Access Compliance Report

Public Rights-of-Way

| Intersection ID: 44943 | Main Street: COLTART_CT | Cross Street: LARIMER_LN | Location: W |
| ADA ID: 56747779E05B | Ramp Type: Perp | Initial Pass/Fail: Fail | Overall Compliance: No |

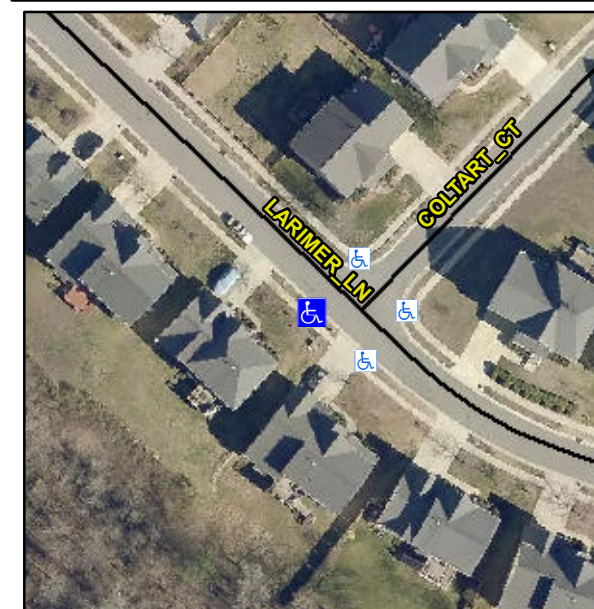
Not Found, R304.5.3

| Compliance | Description | Data | Compliance | Description | Data |
|------------|-----------------------|-------|------------|-----------------------------|------|
| Yes | Ramp Width (in) | 48.0 | No | Ramp XSlope (%) | 3.0 |

Remove & Replace Entire Ramp.
